**Cogentrix Quail Brush Generation Project - Docket Number 11-AFC-3,
Supplement 3 to the AFC**

**APPLICATION FOR CERTIFICATION
FOR THE *QUAIL BRUSH GENERATION PROJECT***

**DOCKET NO. 11-AFC-03
PROOF OF SERVICE
(Revised 8/14/2012)**

FIGURE 1.1-3
PROPOSED SDG&E 138 kV
LOOP PLAN AND PROFILE DRAWING

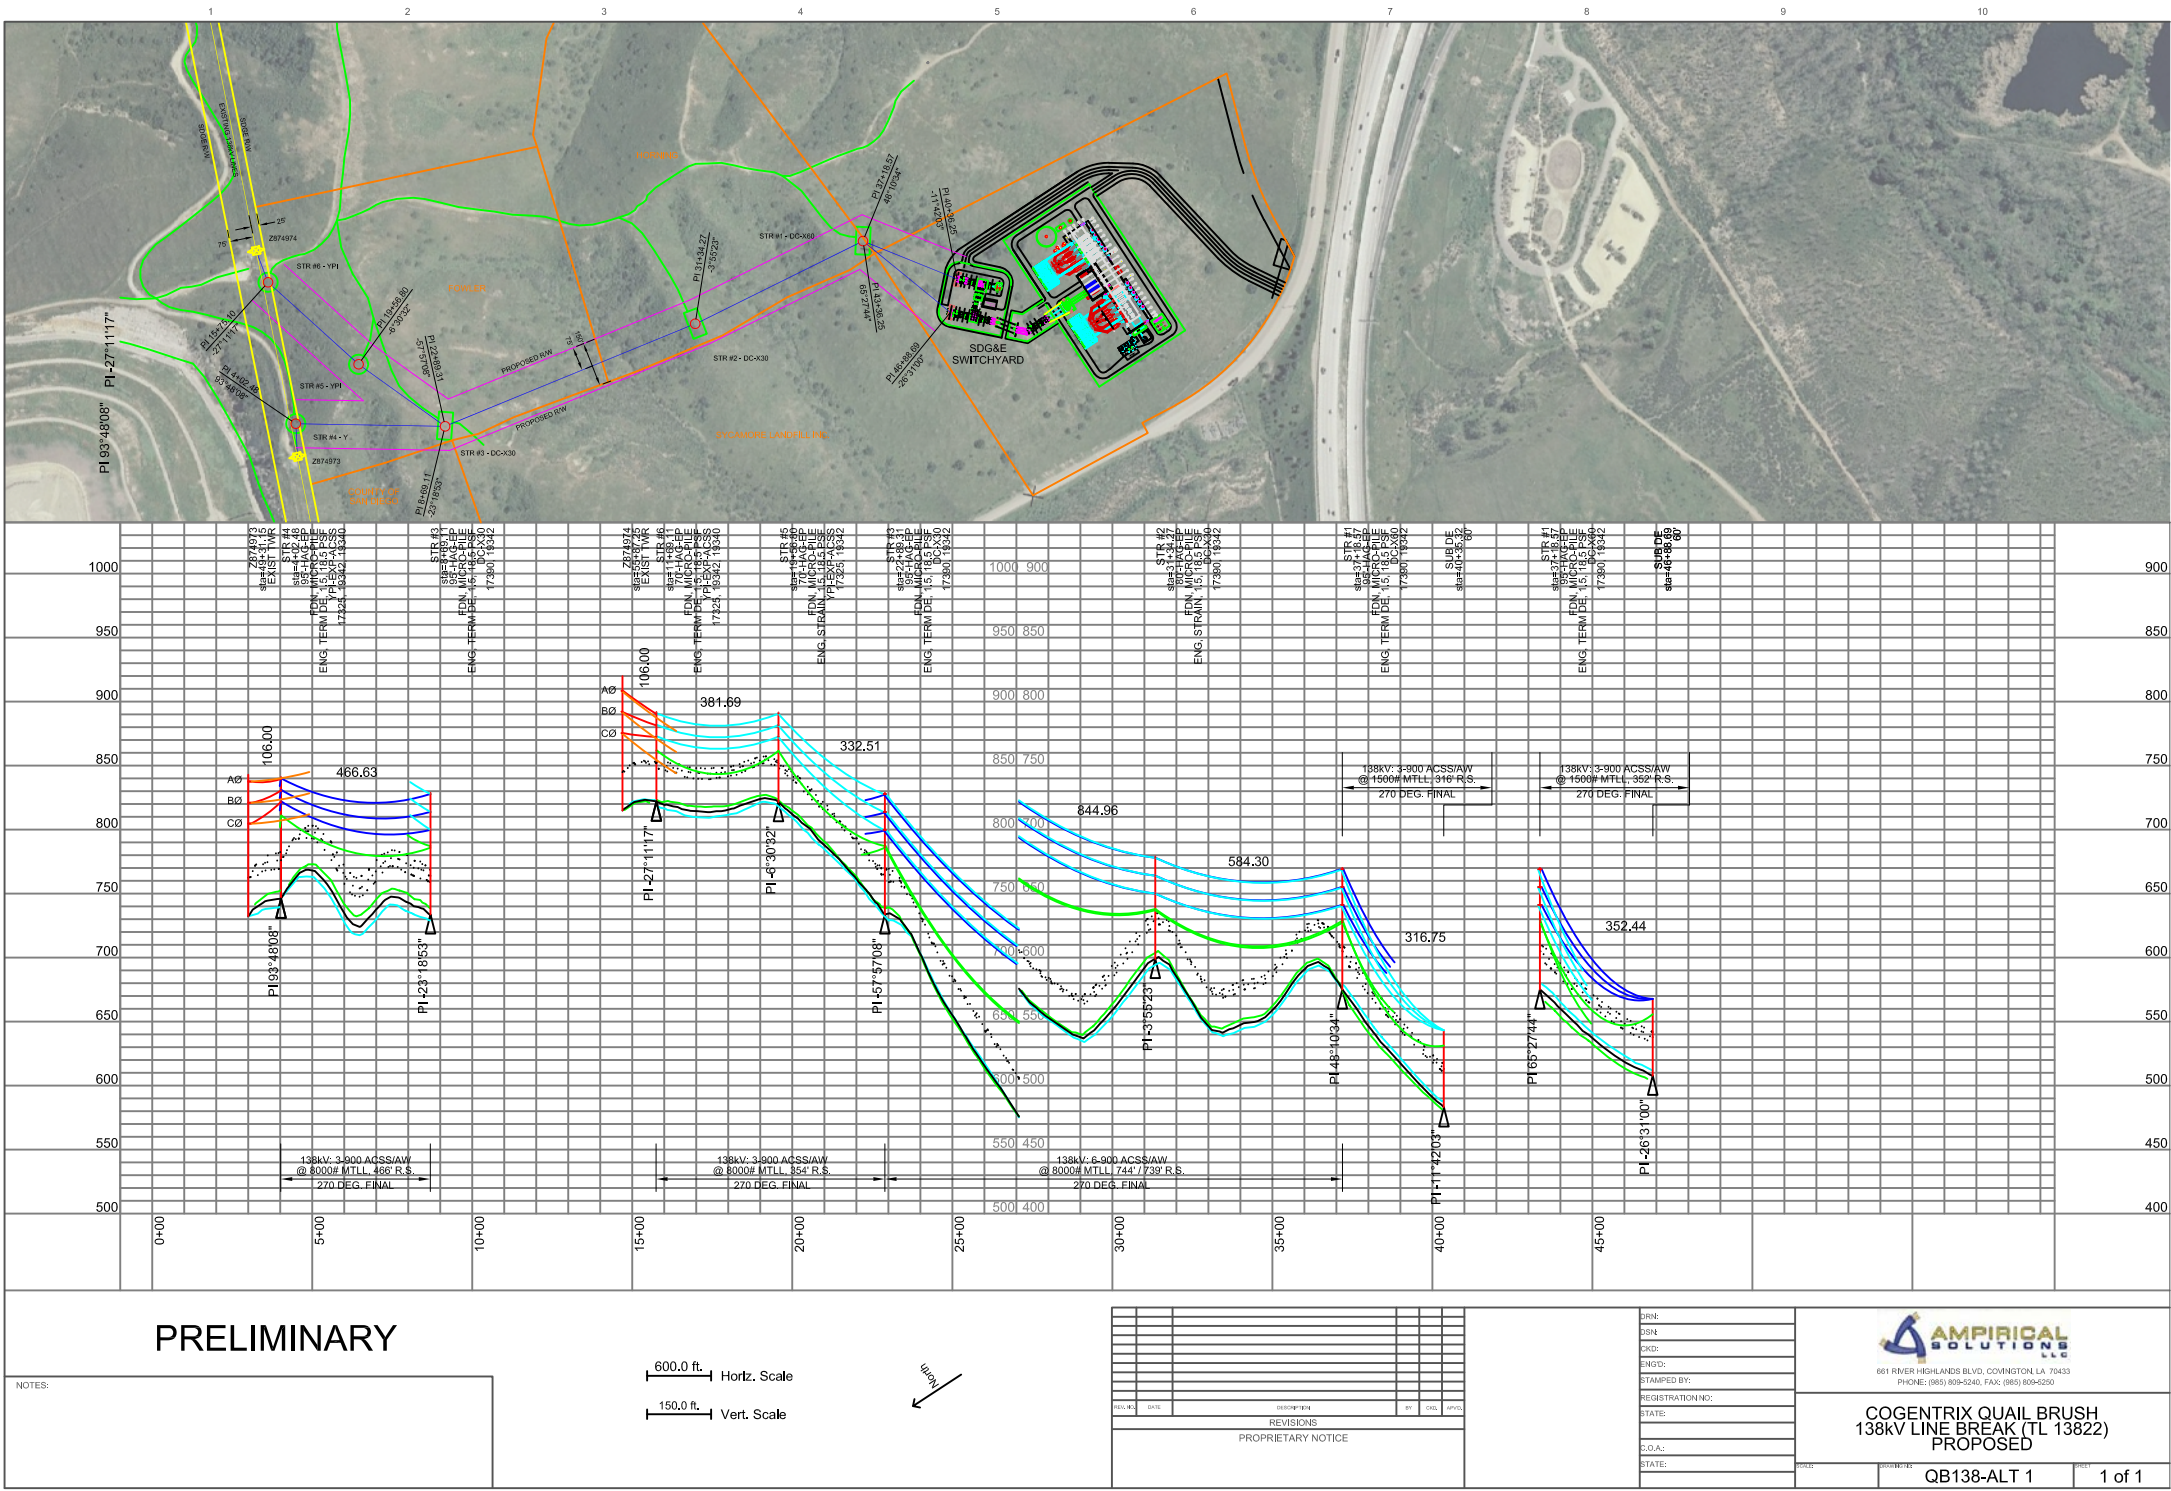
The proposed 138 kV loop would originate between the existing lattice towers Z874973 & Z874974, which support both the TL 13821 and TL 13822 lines. The proposed 138 kV loop would consist of two overhead three-phase transmission line circuits that would begin at the line break of TL 13822 in the existing SDG&E 138 kV corridor and proceed south, approximately 2,700 feet, to dead end structures located inside the new SDG&E 138 kV utility switchyard (Figure 1.1-2). The exact routing of the loop from the SDG&E corridor to the new onsite SDG&E utility switchyard will be determined in consultation with SDG&E during route survey and detailed design.

Two routes are being considered for the 138 kV loop and are located in an undeveloped rural area: the Proposed SDG&E 138 kV Loop and the Alternative 1 SDG&E 138 kV Loop (Figure 1.1-1).

FIGURE 1.1-4
ALTERNATIVE 1 SDG&E 138 kV
LOOP PLAN AND PROFILE DRAWING

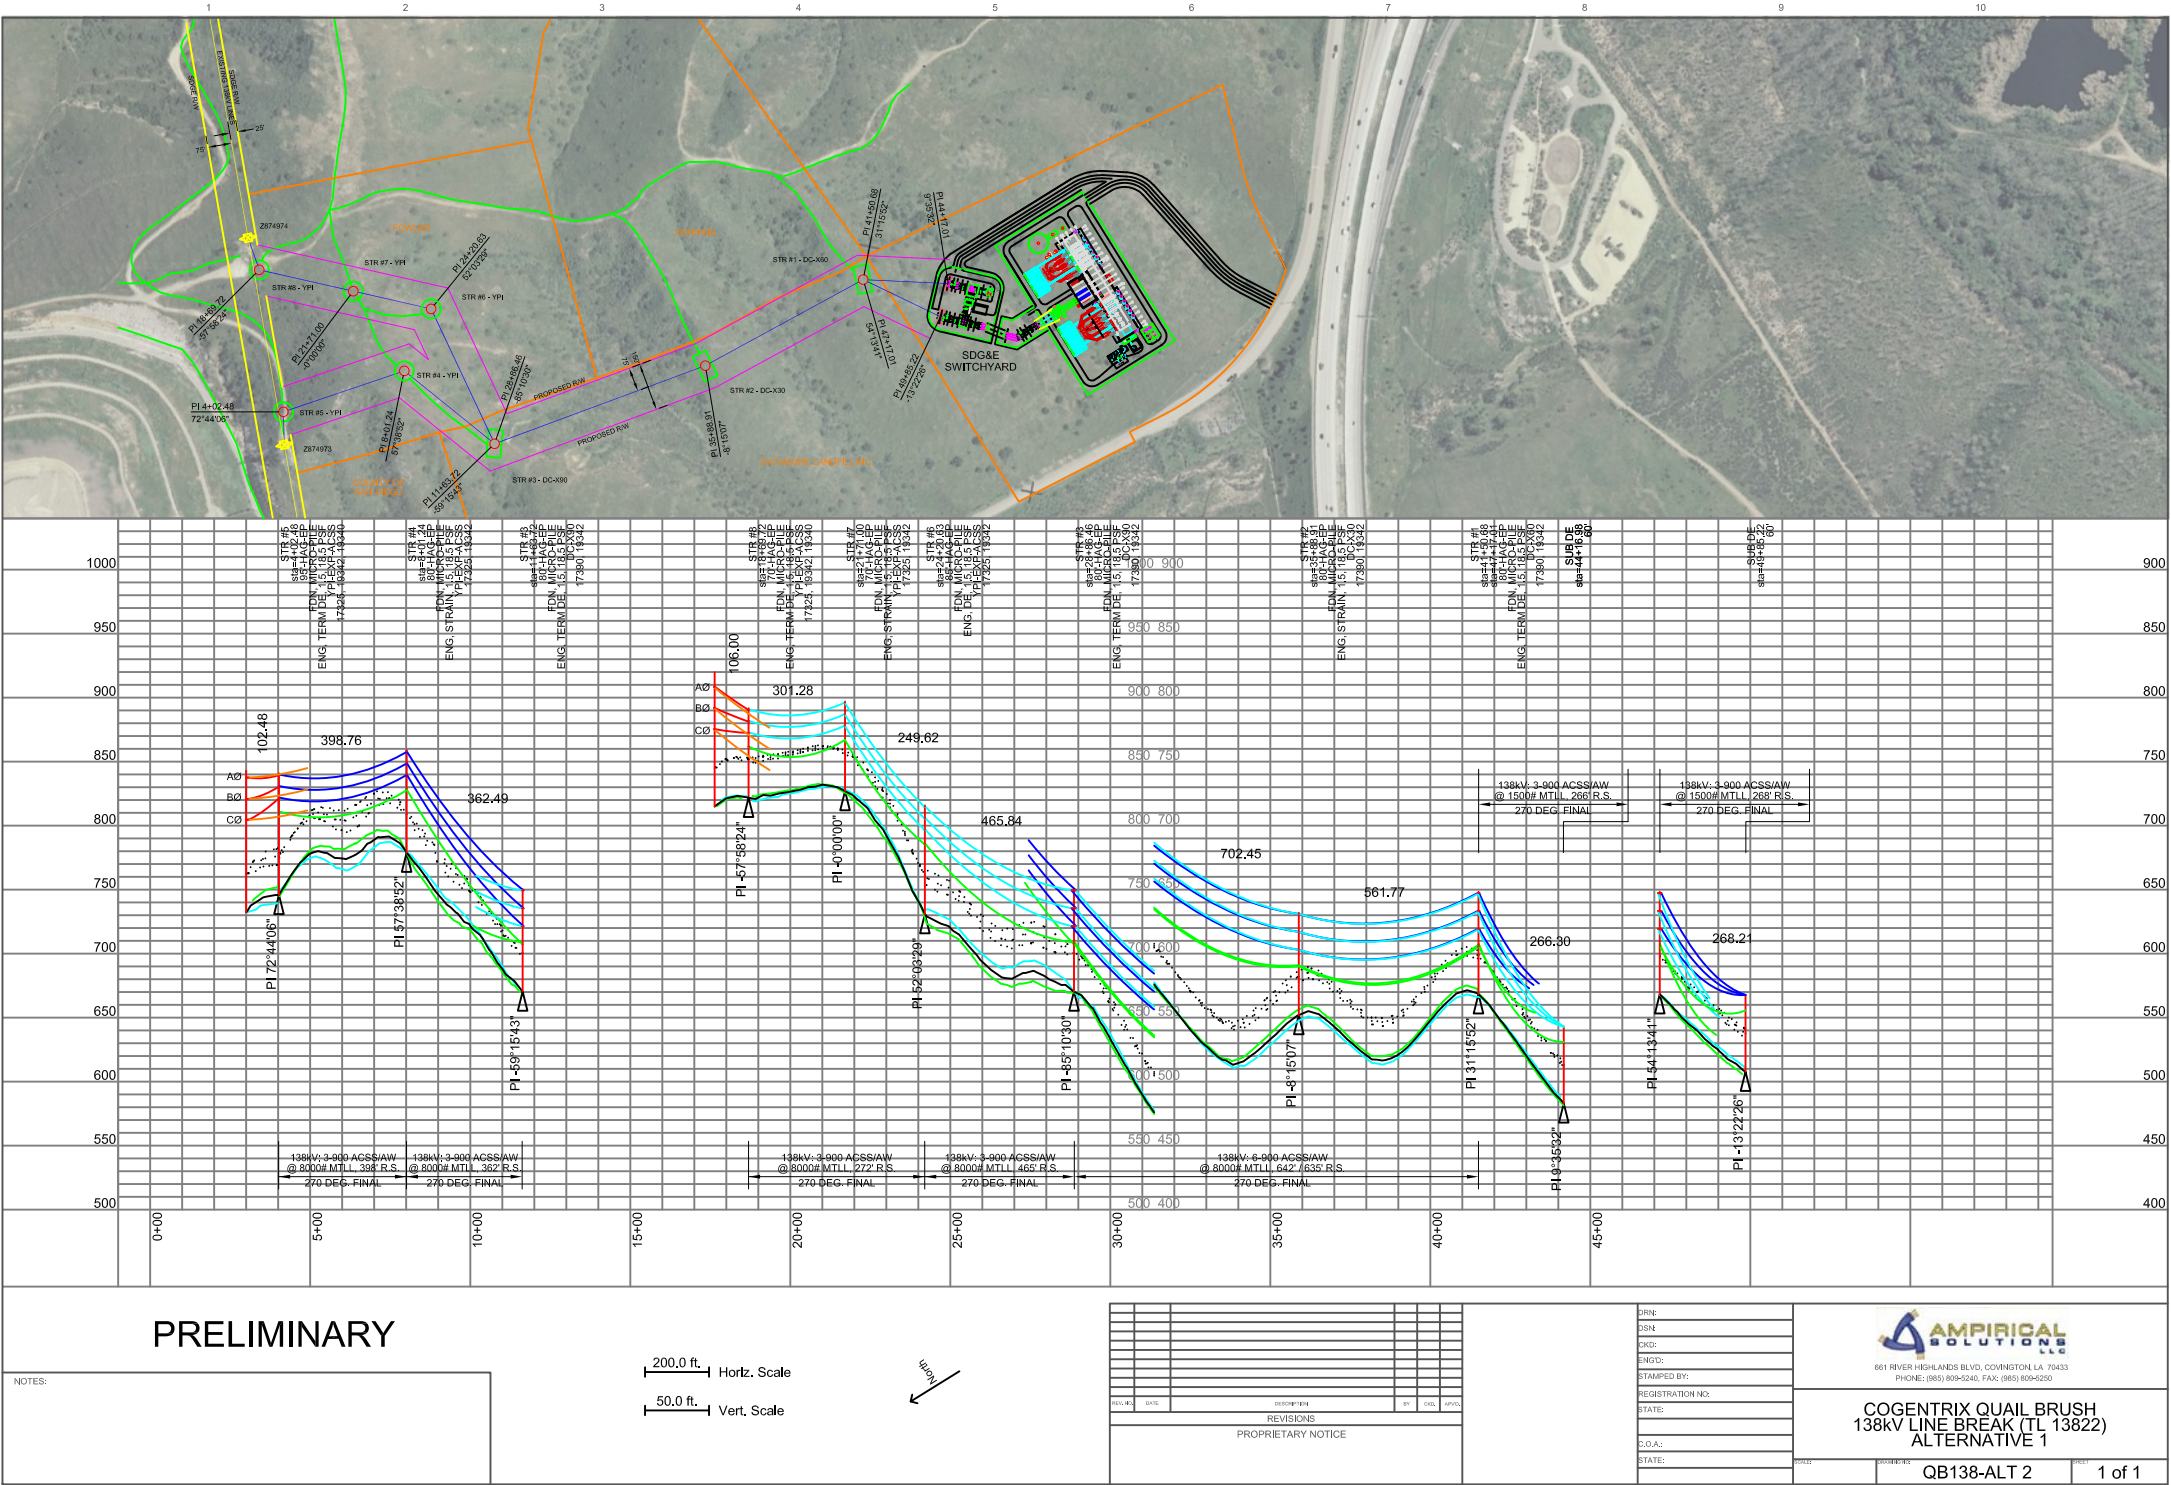
- The Alternative 1 SDG&E 138 kV loop would start at the dead-end structure inside the SDG&E utility switchyard on the northeast side of the plant and connect to the double circuit monopole located in parcel 36608058. The Alternative 1 SDG&E 138 kV loop would utilize double DC-X davit arm monopole structures proceeding north through parcel 36608027 just inside the east property line for approximately 1,264 feet, then split into (2) single circuit lines utilizing YPI vertical dead-ends with jumpers and travel northeast and east through parcel 36608028 for approximately 863 & 1,123 feet and then cut into the SDG&E 138kV (TL 13822) existing lattice tower line (Figure 1.1-4).

**FIGURE 4.14-1
POST DEVELOPMENT
PRELIMINARY GRADING PLAN
AND SITE ARRANGEMENT**

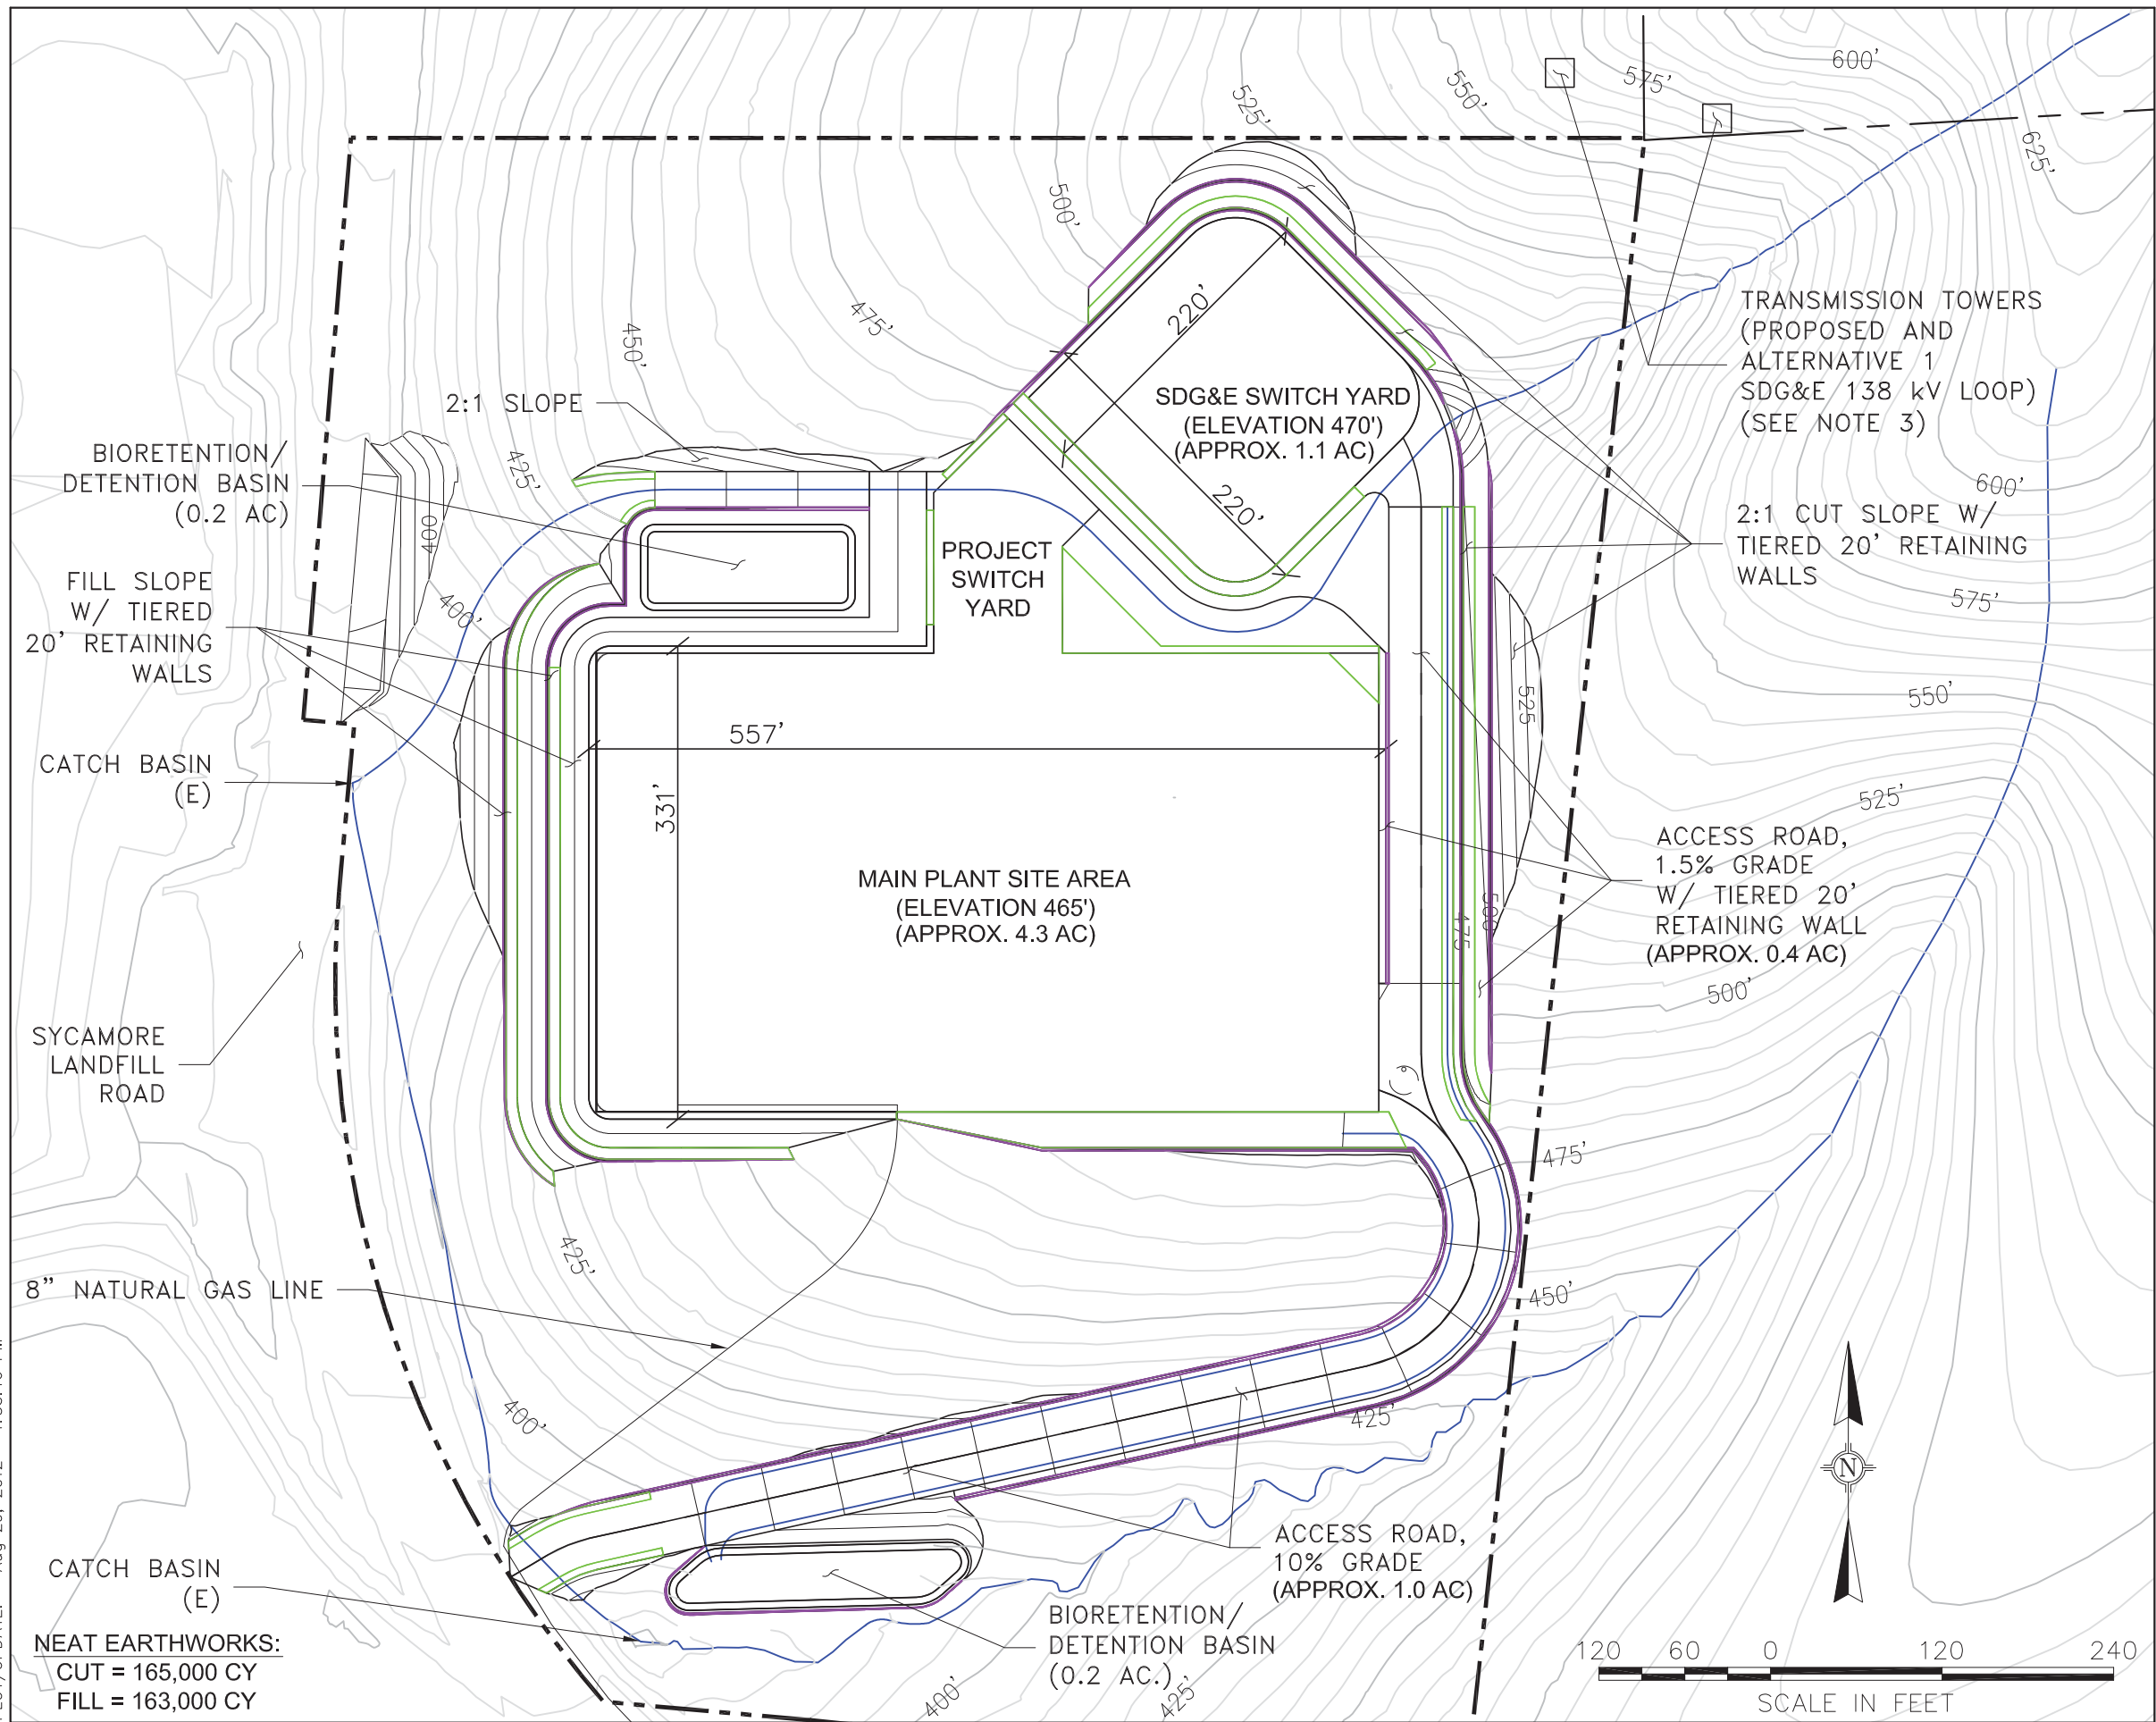
The preliminary grading plan (Figure 4.14-1) includes the finished grade elevations and preliminary contour lines across the entire plant site. The combination of relocating the plant site 150 feet farther south and co-locating the SDG&E utility switchyard within the proposed Project site increased the estimated earthwork quantity slightly.
